Brisbane Central Business District Bicycle User Group

CBD BUG submission:
Brisbane City Council Draft Local Government Infrastructure Plan (LGIP) 2016-2026

Figure 2.2: Guidance on the separation of cyclists and motor vehicles for the preferred bicycle route

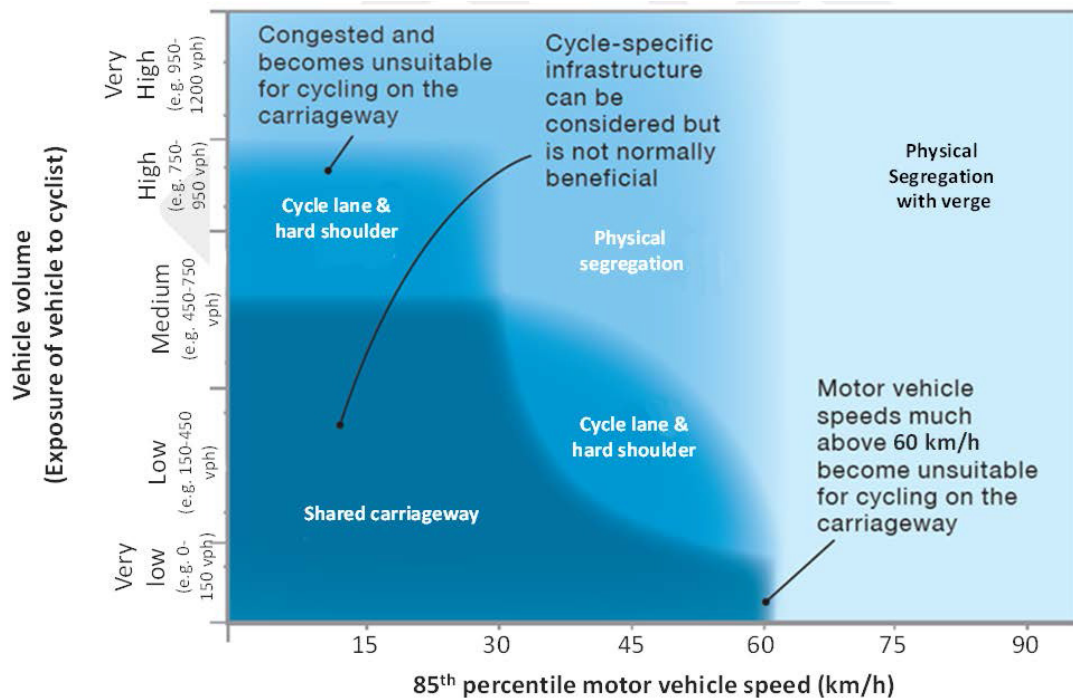
A number of sections in Part 6 outline the relationship between road space and people riding bicycles. Disappointingly none of them seem to have taken into account the most recent Austroads guidance outlined in AP-G88-17_Cycling_Aspects_of_Austrroads_Guides. Figure 2.2 from this guide shows when physical separation is required between motor vehicles and people riding bicycles. If Brisbane is to achieve the mode share targets set out in the strategic documents that inform the LGIP, these guidelines are the minimum that must be followed.

The following sections should be amended to reflect this guidance, as they seem to reflect a view that a bicycle lane, is physical segregation. It also appears that these tables are internally inconsistent, with one aspect of the function of the road being “physically segregating different modes”, yet the cross section includes “a bicycle lane”, as does the On Road, Cycling Characteristic. A painted white stripe, inside which cars can legally be parked, does not constitute physical segregation.

We note the speed and volume characteristics of Figure 2.2 advise that physical segregation is required on District and Neighbourhood roads depending on speed and volume:
